MONTGOMERY COUNTY HISTORIC PRESERVATION COMMISSION
STAFF REPORT

Address:	2115 Salisbury Road, Silver Spring	Meeting Date:	5/8/2024
Resource:	Outstanding Resource (Linden Historic District)	Report Date:	5/1/2024
Applicant:	Brett Howard	Public Notice:	4/24/2024
Review:	HAWP	Staff:	Dan Bruechert
Case Number:	1066554	Tax Credit:	N/A
PROPOSAL:	Hardscaping, landscape alteration, gazebo removal, and tree removal

Pathway Lights

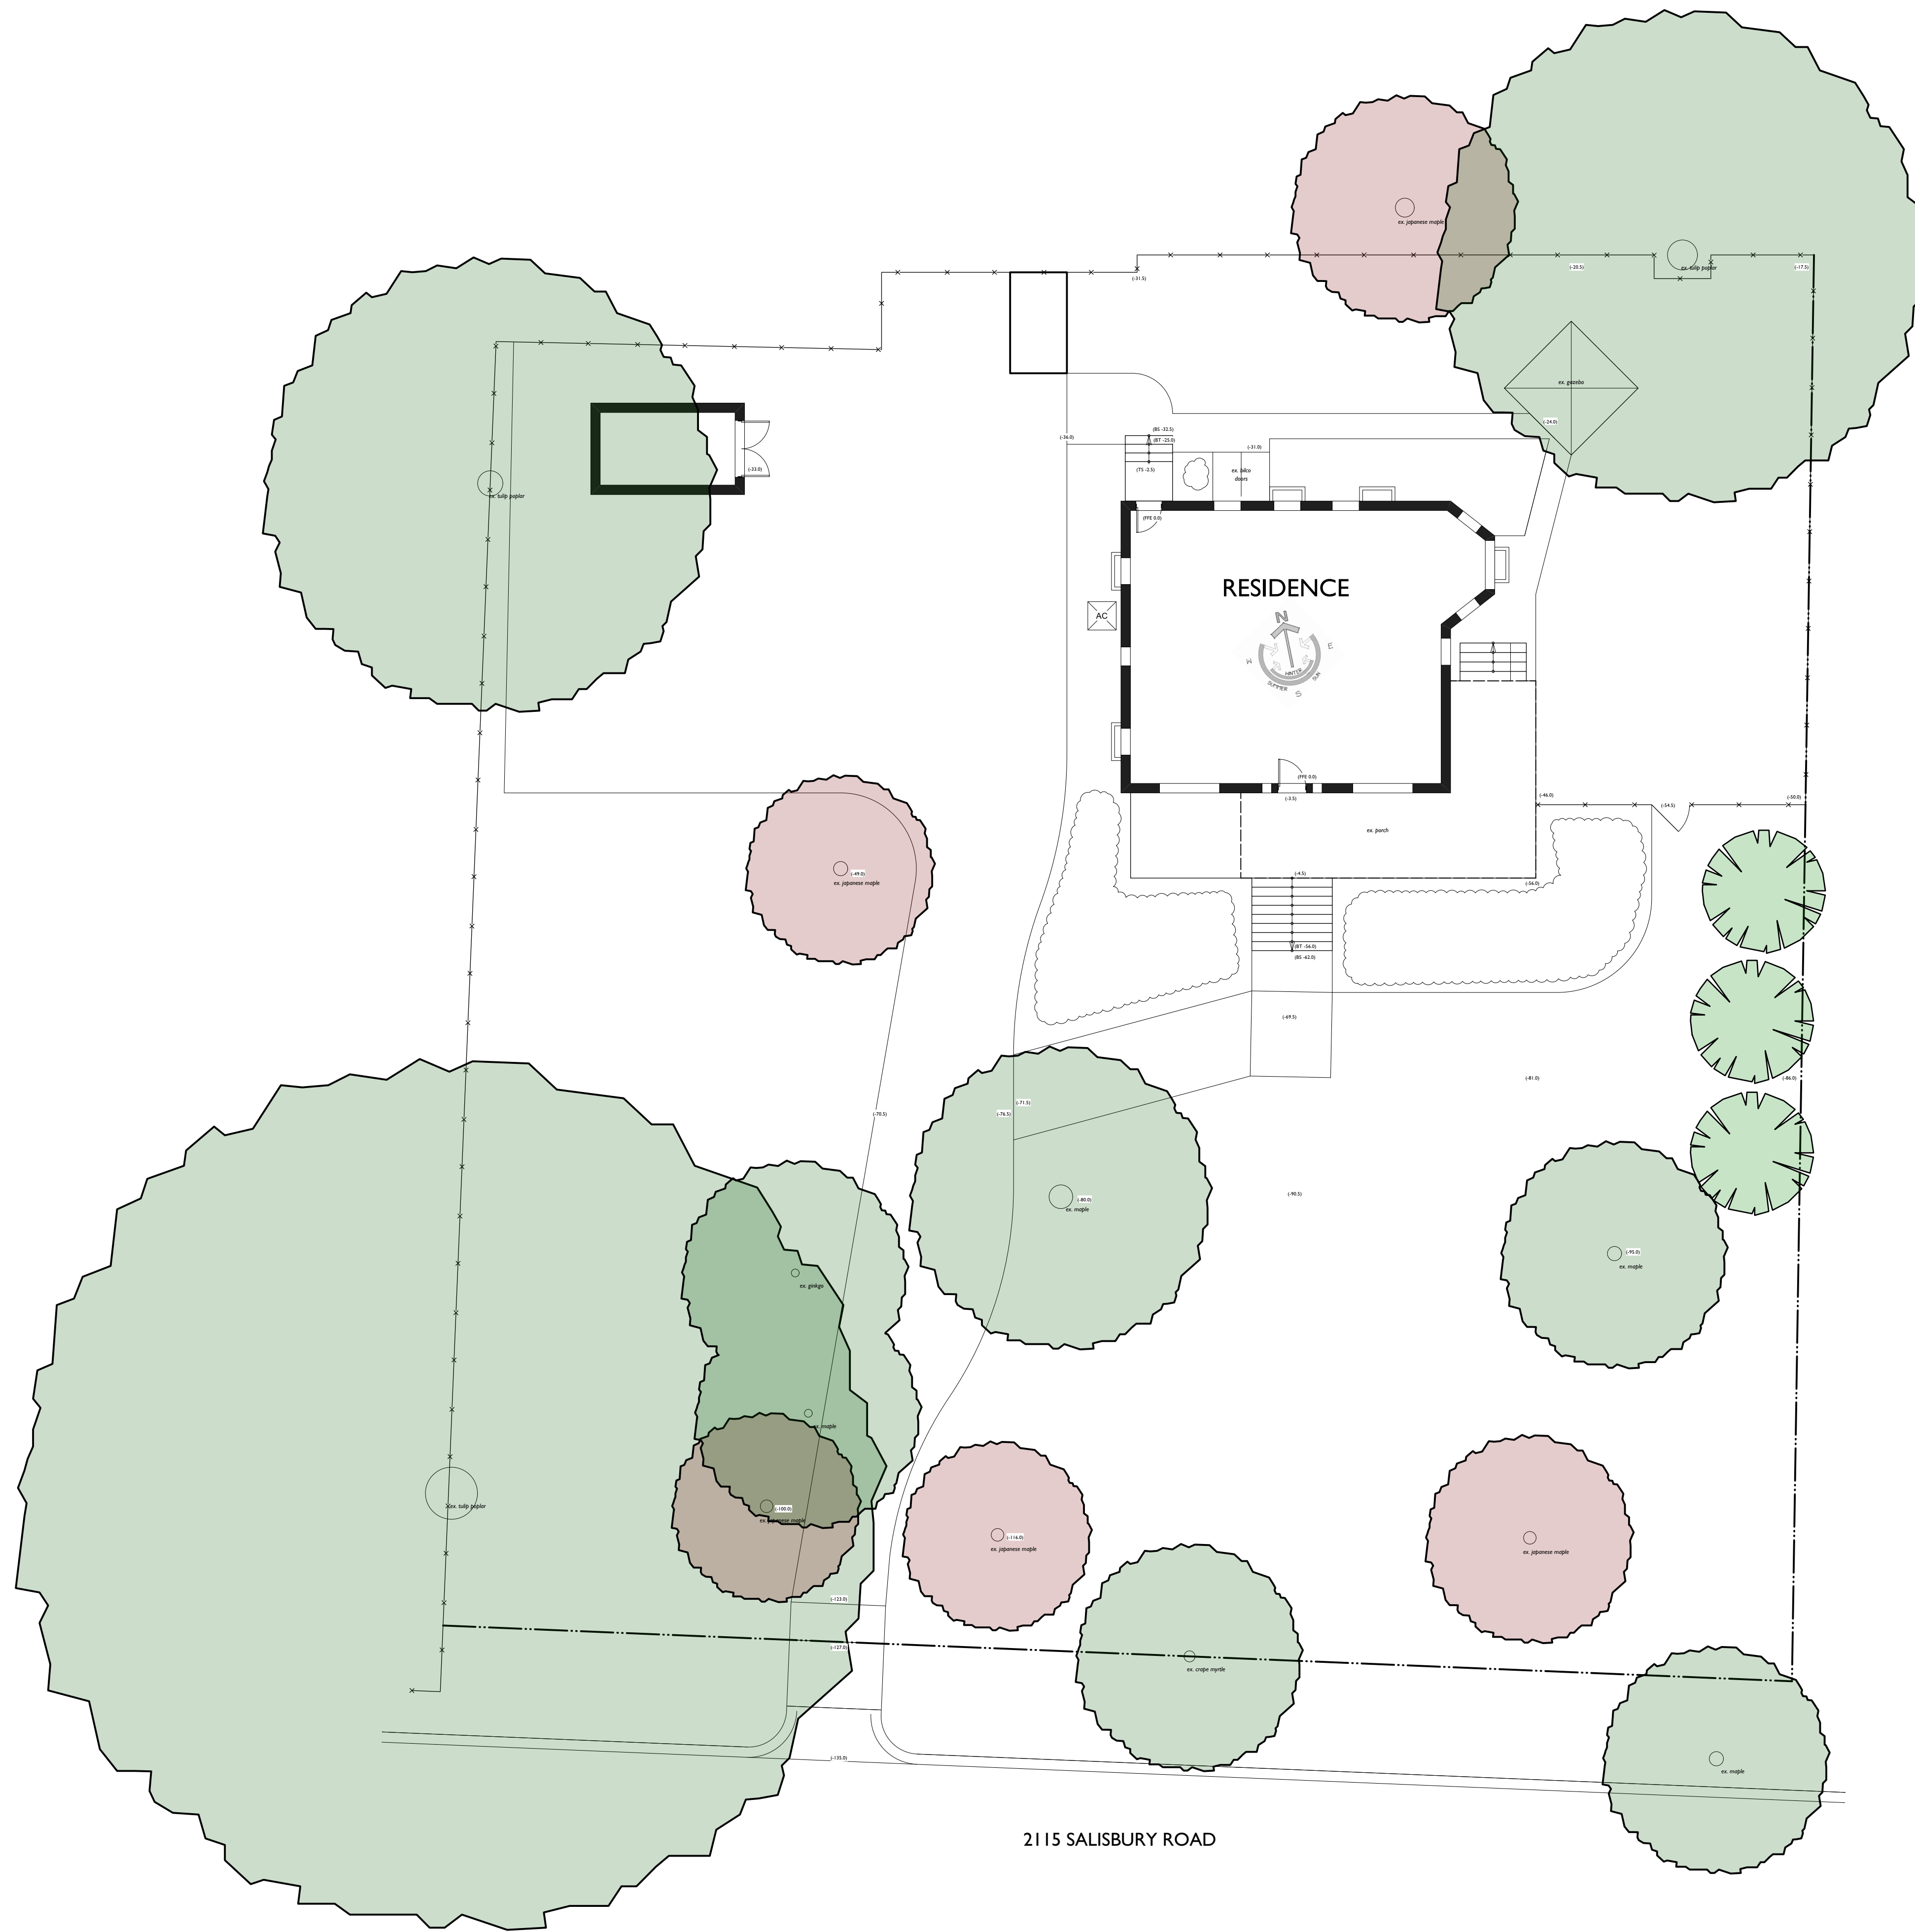
The applicant proposes to remove the existing driveway and construct a new driveway using permeable pavers with a 9" contrasting border; the existing concrete apron will also be removed and replaced with pavers. The front concrete walkway will also be removed and replaced with pavers matching the driveway and will be expanded to wrap around the east side of the house. At the rear, the applicant proposes to construct a large patio, measuring approximately 19' × 36' (nineteen feet deep by thirty-six feet wide). The description of the work in the application identifies two potential manufacturers and colors of pavers but does not include the product line. A patio measuring 13' 6" × 16' (thirteen feet, six inches deep, by sixteen feet wide) will be installed directly behind the approved ADU. Finally, the applicant proposes to construct several new paths that will connect several of the outdoor elements. The paths are to be constructed using flagstones set in mortar with a decorative edging. All of the paths are located at the rear of the house.

Staff finds the existing landscaping at the rear of the property does not contribute to the historic character of the site or the surrounding district. While Staff generally prefers to see gravel driveways retained, Staff finds the proposed paver driveway will retain some of the existing driveway's texture, while improving drainage on the site. Staff additionally finds the proposed edged gravel is compatible with the formality of house design. Staff cannot provide any analysis for the proposed material, because the applicant did not provide a specification. However, Staff finds that a rustic paver is appropriate at the subject property and recommends the HPC include a condition for approval to this HAWP that delegates final review and approval authority to Staff and requires this information before final permit documents can be released. Staff recommends the HPC approve the new driveway under 24A-8(b)(2) and Standards 2, 9, and 10.

Staff further recommends the HPC approve the proposed paths. The paths are in locations that will not be visible from the right-of-way and Staff finds the proposed flagstones are compatible with the character of the site and surrounding district. Staff recommends the HPC approve the proposed paths under 24A-8(b)(2) and Standard 2.

The description of work in the application includes removing two trees, a ginko and a holly tree, to accommodate the proposed driveway. The description of the trees is 'medium-sized' and a diameter breast height (d.b.h.) measurement was not provided. The submitted site plan identifies one ginko tree immediately to the west of the driveway, but Staff was unable to find a holly.

Staff generally finds the character of the lot will not be significantly impacted by the loss of two trees, however, the information submitted does not provide enough information for Staff to come to a reasoned recommendation and instead recommends the approval of this HAWP not extend to the tree removal and require the applicant to return for an amendment to this HAWP. If the trees are smaller than 6" d.b.h. (six inches in diameter at breast height), then a HAWP is not required.

1. A material specification for the pavers for the driveway and front walk must be provided to Staff for review and approval. Final approval authority is delegated to Staff.
2. The approval of this HAWP does not extend to the removal of any trees larger than 6” d.b.h. (six inches in diameter a breast height). Any tree removal must be submitted to the HPC as an amendment to this HAWP or under a new permit number.
